Docket Item # 15
BAR CASE # 2009-0124

BAR Meeting
July 8, 2009

ISSUE: Alterations

LOCATION: 209 South Fairfax Street

Figure 3: Existing and proposed floor plan.

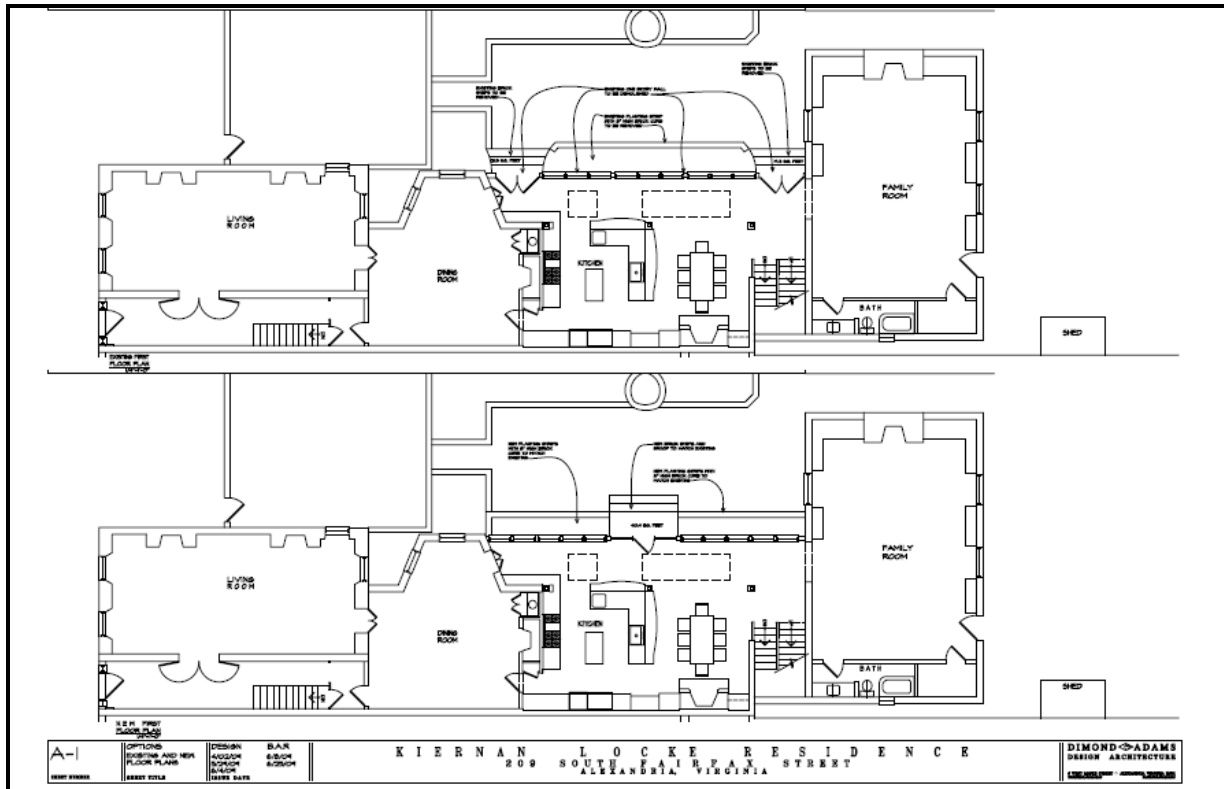
The new south elevation will be located on the same footprint of the existing wall. Instead of two entrances, the proposed new elevation will contain a single door flanked by fixed door panels, with a brick stoop and iron railing. On either side of the centered entrance there will be five, double-hung, six-over-six wood windows. The materials used – wood trim and brick – will match those used on the existing porch.

Figure 4: Existing and proposed elevations.

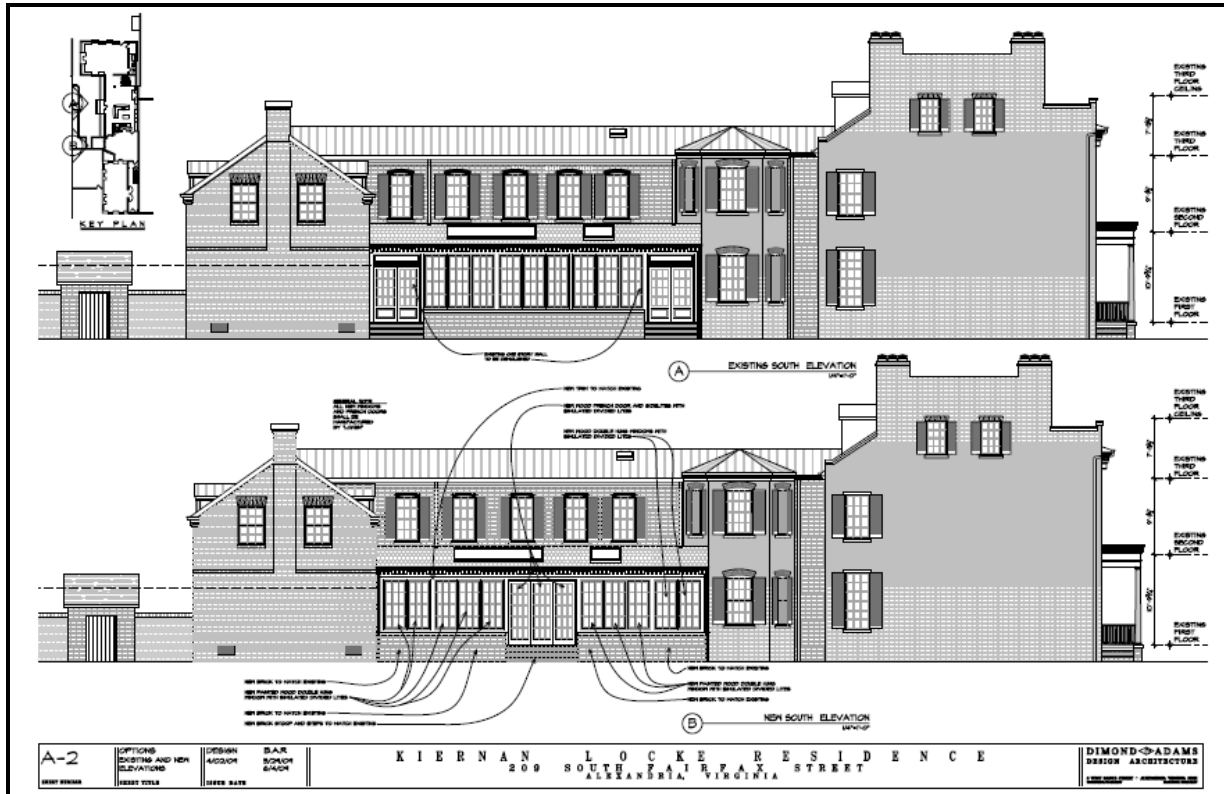
In the opinion of Staff, the proposed new south wall of the existing enclosed porch is appropriate. Although the elevation will be reconfigured to accommodate a central entrance, the intent and character of the enclosed porch is maintained.

While single-glazed, true divided light wood windows are preferable, the *Design Guidelines* and the Board generally allow for double-insulated, simulated divided light wood windows and doors on new construction or in areas with limited visibility. Given the age of the enclosed porch (1955-1956) and the limited visibility once the brick wall at the front of the property is restored, Staff finds that the proposed windows and doors are appropriate. The same Loewen windows were approved by the Board on February 7, 2009 for the second story addition at the rear of the house.

Staff recommends approval of the application with the condition that the front garden wall be rebuilt using the original bricks following the completion of the construction project.
